Mr James Grayburn  
RIIO-GD1  
Office of Gas & Electricity Markets  
9 Millbank  
London  
SW1P 3GE

24<sup>th</sup> September 2012

### **WWU response to Ofgem's RIIO GD1 Initial Proposals**

## 2. Capital integrity allowances

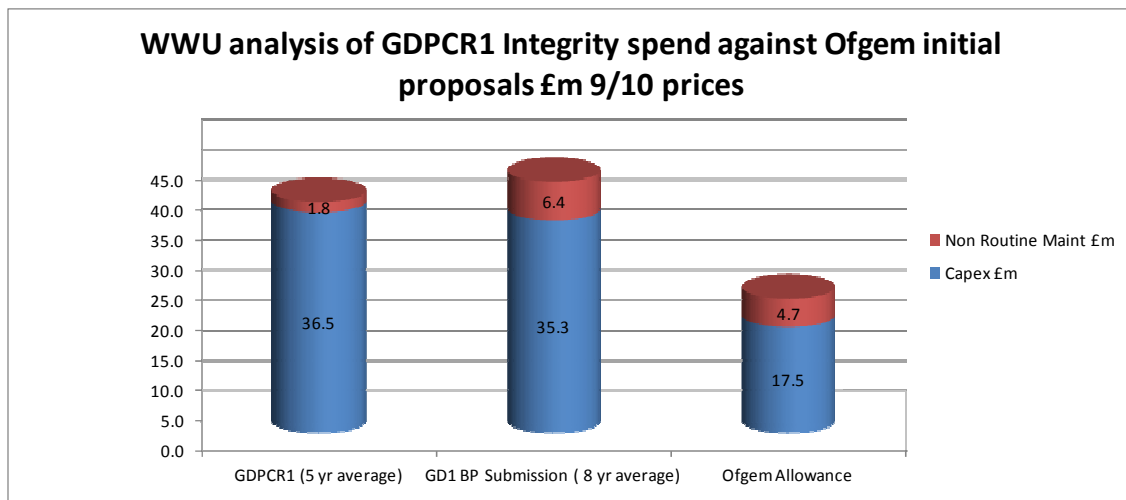
However, it appears that Ofgem has allowed an insufficient integrity related allowance within RIIO-GD1 for WWU as indicated in the chart below.

- The WWU average actual spend through GDPCR1 on integrity Capex and Non Routine Maintenance is circa £40m per annum. 95% of spend is on capital solutions,
- The Proposed Ofgem allowance for RIIO-GD1 is circa £22m. The allowance is approximately 60% of the WWU GDPCR1 spend for WWU, despite assets getting older and deteriorating, and
- The WWU RIIO-GD1 business plan has introduced a significant shift from Capex solutions to Opex solutions that provide best option for consumers and clearly help reduce the risk of stranding. Our proposal is 85% Capex and 15% Opex – hence the increase in Non routine Maintenance within an overall total which is aligned to the GDPCR1 spend.

The chart clearly shows that WWU has not asked for a significant increase in integrity related spend in RIIO-GD1 over GDPCR1. We have however, introduced more Opex based solutions into our planning, reducing the future risk of asset stranding to the benefit of current consumers.

**Projected 10 year trailing average cost of debt allowance during the RIIO-GD1 Period**

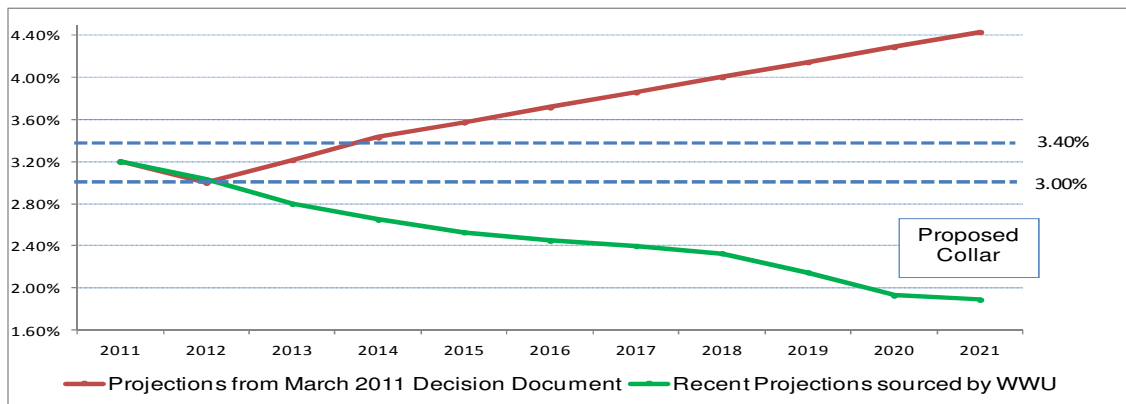
As an illustration of the issue, WWU has previously presented the graph below to the GEMA board

The risk to WWU is further exacerbated by the potential for further significant falls in the index during the RIIO-GD1 period. The projections above show the index falling below 2% prior to the end of the RIIO-GD1 period. As with all economic forecasts, there are clearly a range of potential outcomes, but there is a significant pro-cyclical risk from debt indexation.

### **3.4.2 Proposed Transitional Mechanism**

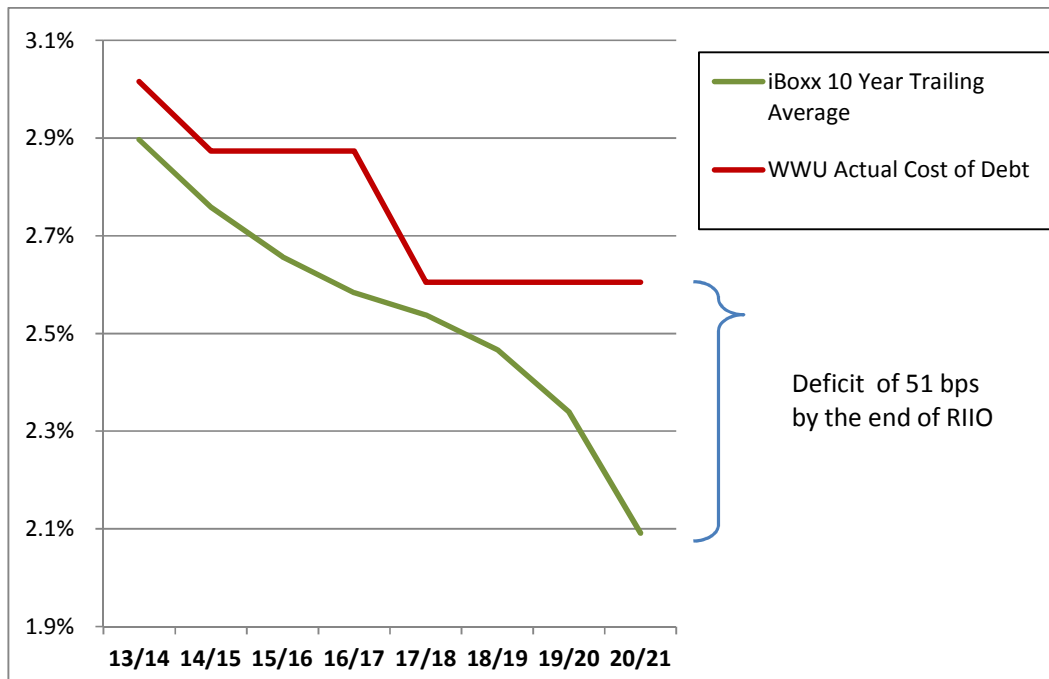
In order to address the above risks, in its April 2012 business plan submission WWU proposed a transitional mechanism that would provide appropriate protection to the network and the gas consumer in equal measure.

An appropriate transitional mechanism would be to implement a collar and thereby set a cap and a floor on the range of potential trailing average values. The benefit of a collar is that it would provide a degree of certainty of returns and allowed revenues, within a range providing protection to networks and gas consumers from economic uncertainties and hence would be consistent with a lower allowed cost of equity, whilst still encouraging networks to behave efficiently.

Our proposal for the mid-point for the collar was the allowed cost of debt under GDPCR1 of 3.55%. The proposed range of the collar was 20bps either side of this mid-point and hence gave a range of potential outcomes for the cost of debt trailing average (including the required uplift for inflation risk premium and other financing costs) of 3.35% to 3.75%.

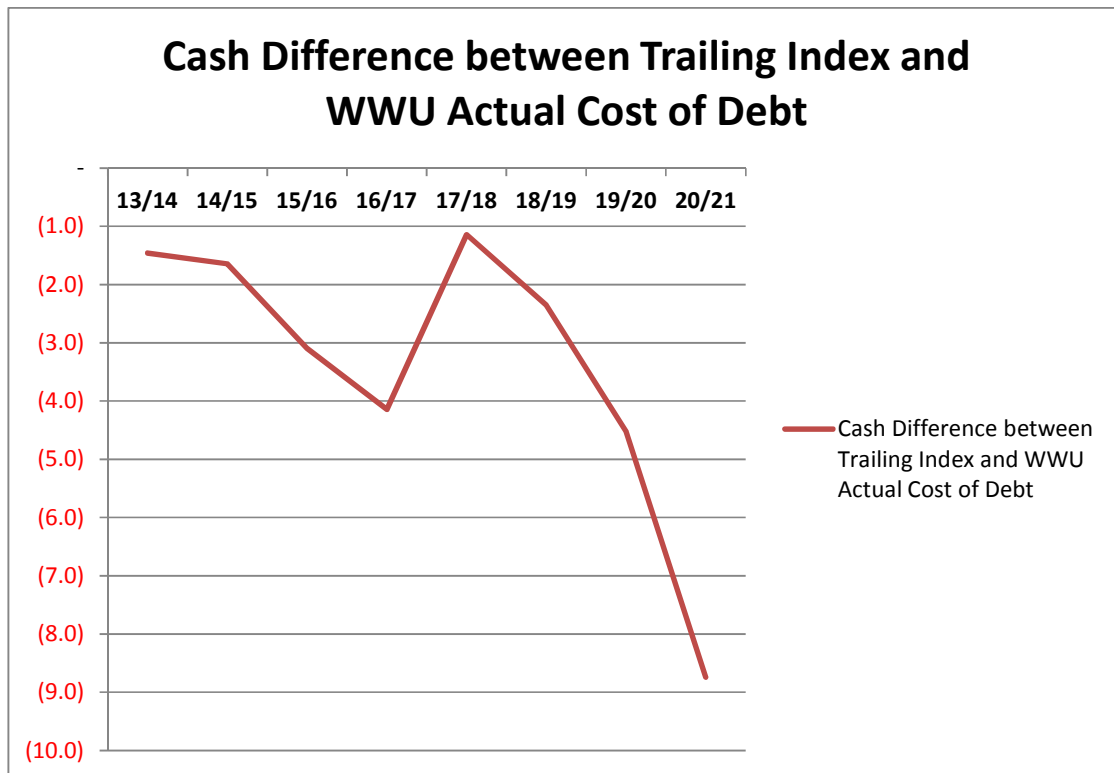
WWU requested the above analysis and identified that an incorrect cost of debt had been used by Ofgem, as it failed to take account of either the hedging arrangements held by WWU or any fees or other necessary financing costs, which are an integral part of the cost of debt. WWU has updated the Ofgem analysis to reflect our actual cost of debt (including hedging arrangements) and the summary of the output is shown in the following graph:

The above analysis is simply a replication of the Ofgem modelling used to assess the sensitivity to a falling index. The above analysis assumes a future annual index value of 2% and that all future debt is issued in line with the index (before fees and other necessary financing costs). It is worth noting that the cost of debt curve for WWU contains a number of limiting assumptions and excludes:

- Any bank debt, liquidity or hedging costs, or any cost of carry from liquidity pre-funding
- Any fees associated with raising debt (issue costs) or ongoing costs (e.g. Rating Agency)

Under the current proposals, all of the above costs are required to be funded by the cost of debt allowance.
